**RE: Lot 33 Block 6 Unser Cliffs SAD 227  
7912 Kibo NW  
Grading and Drainage Plan  
Engineers Stamp Date 10/2/17 (E10D039)  
Pad Certification Date 5/25/18**

## DRAINAGE AND TRANSPORTATION INFORMATION SHEET (REV 09/2015)

**Project Title:** 7912 Kibo nw **Building Permit #:** **City Drainage #:** E10D039  
**DRB#:** **EPC#:** **Work Order#:**  
**Legal Description:** lot 33 block 6 Volcano cliffs, UNIT 2  
**City Address:** 7912 Kibo NW

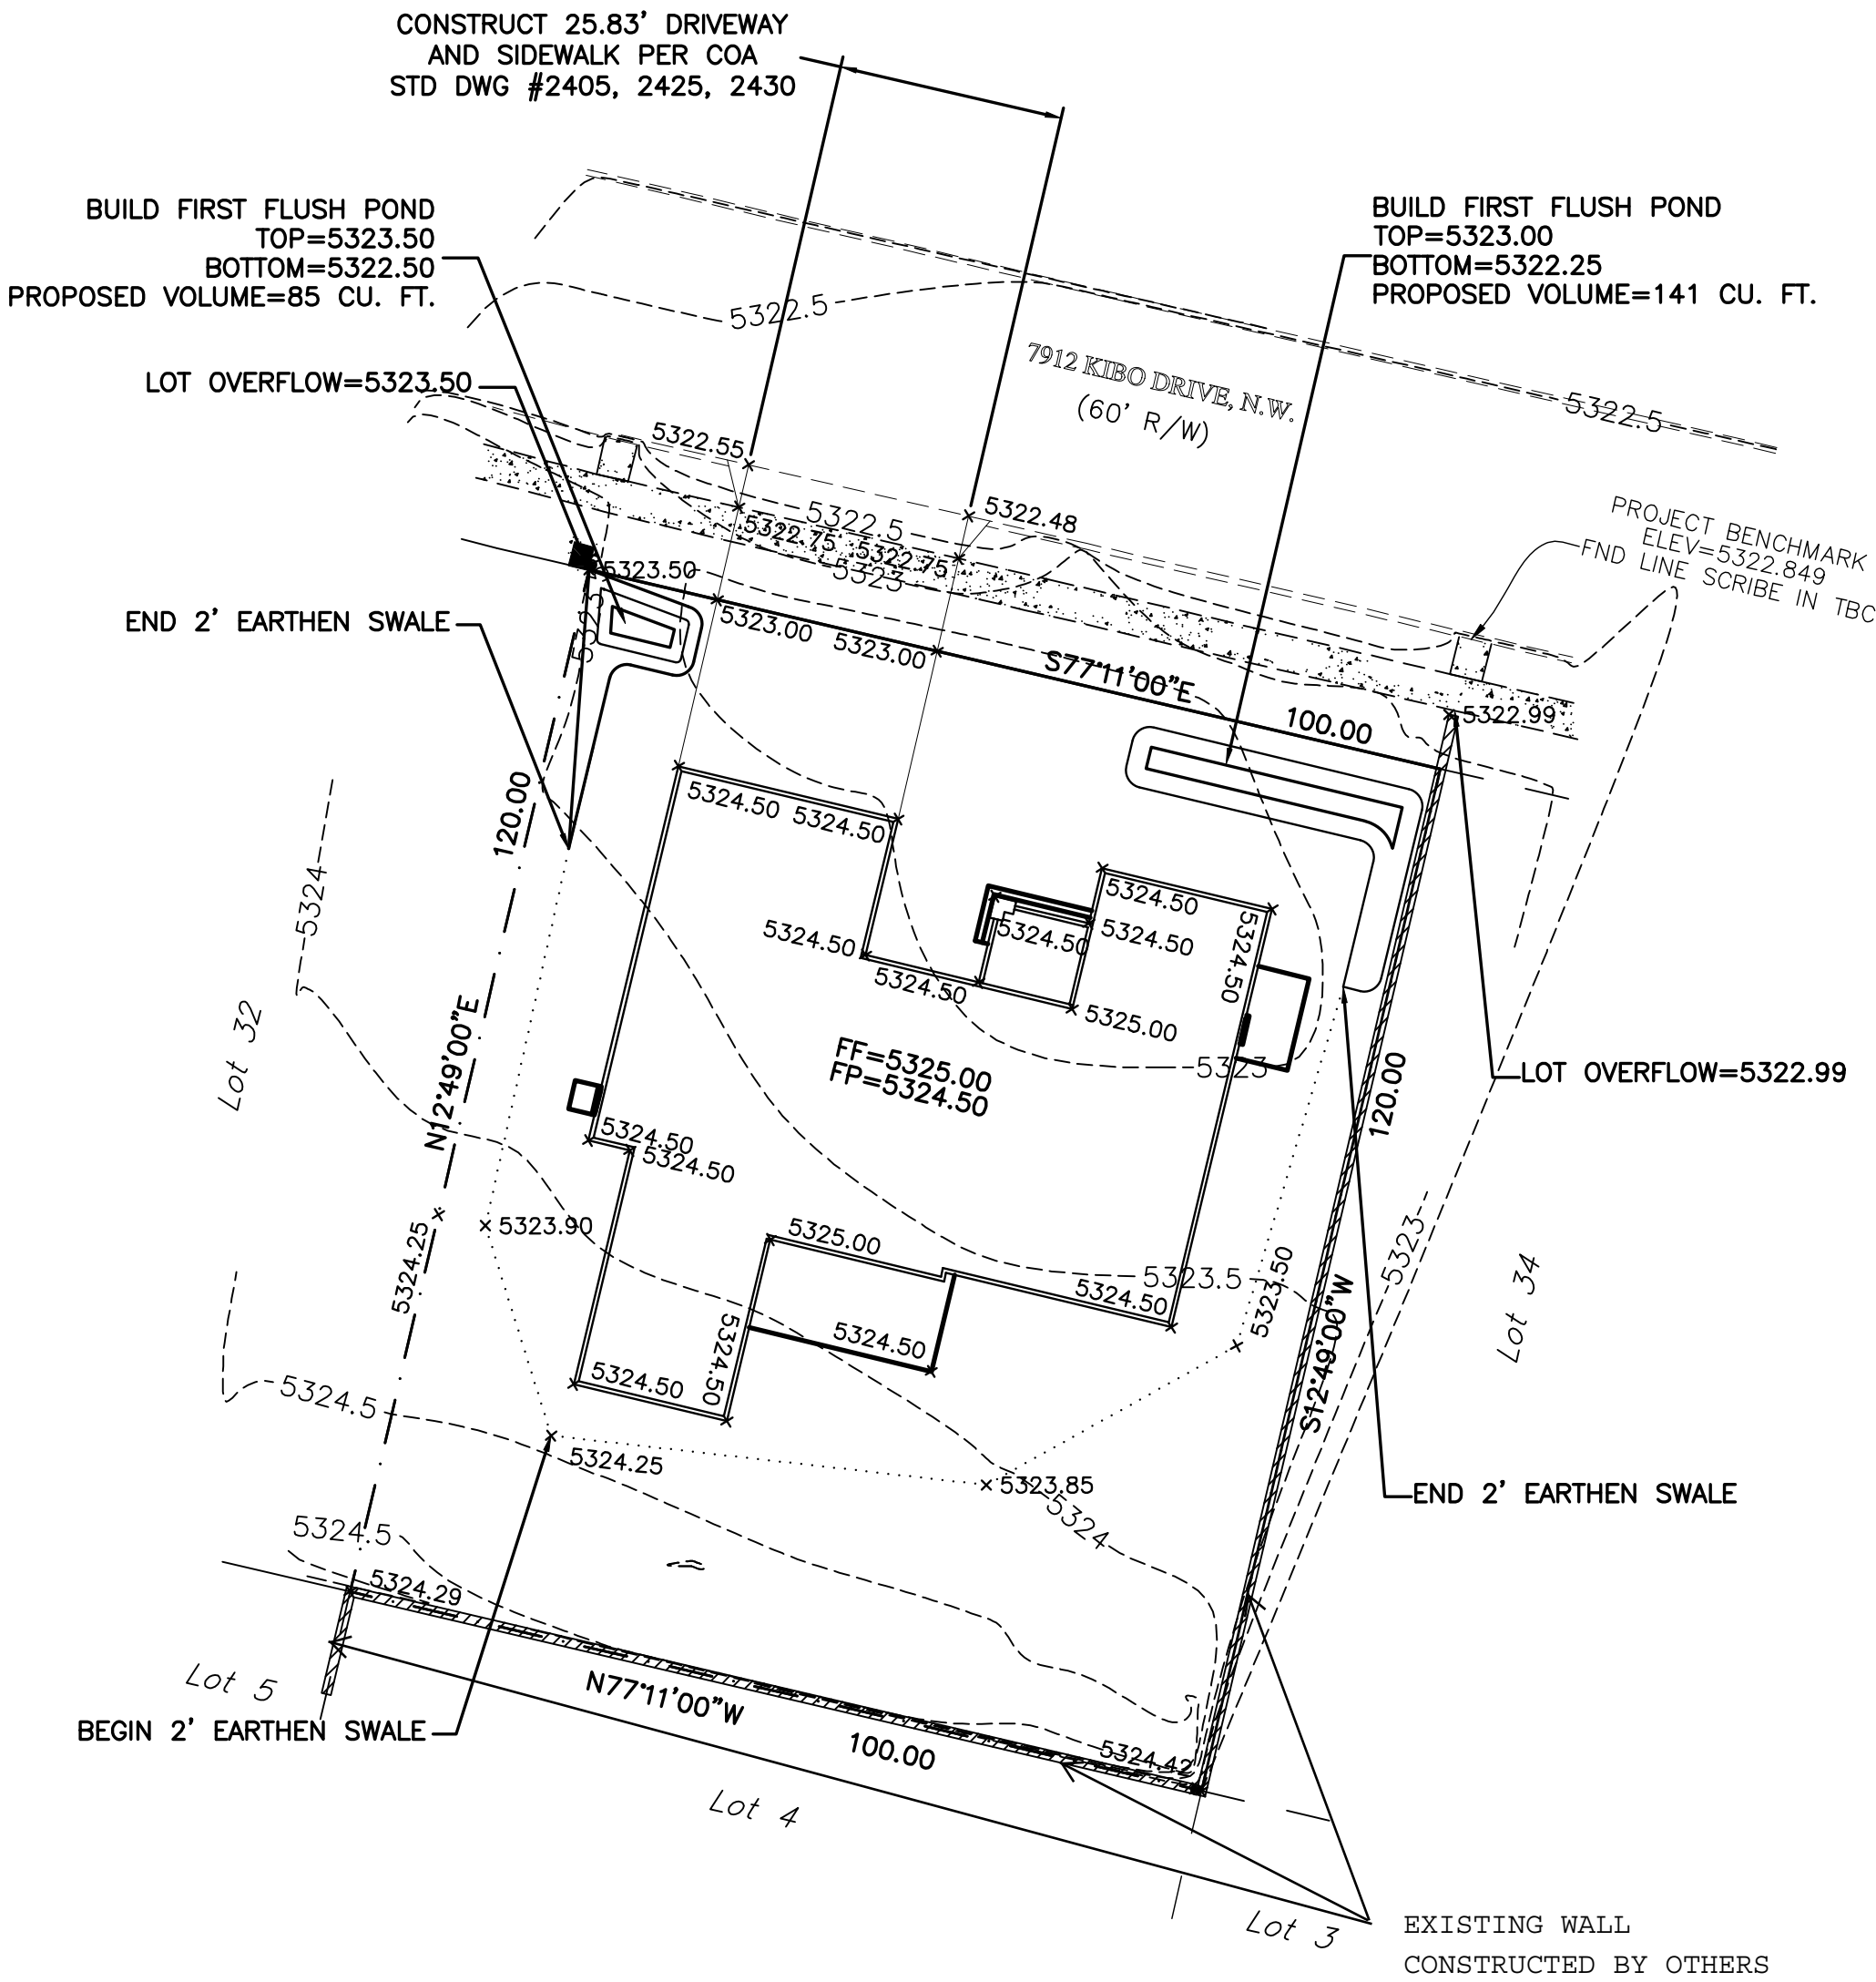
Based upon the information provided in your submittal received 2/9/18, this plan is approved for Building Permit.

Reiterate to the Owner/Contractor that a separate permit for a garden/retaining wall must be obtained, with the approved G&D plan dated 10/2/17.

Prior to Certificate of Occupancy release, Engineer Certification per the DPM checklist of this plan will be required.
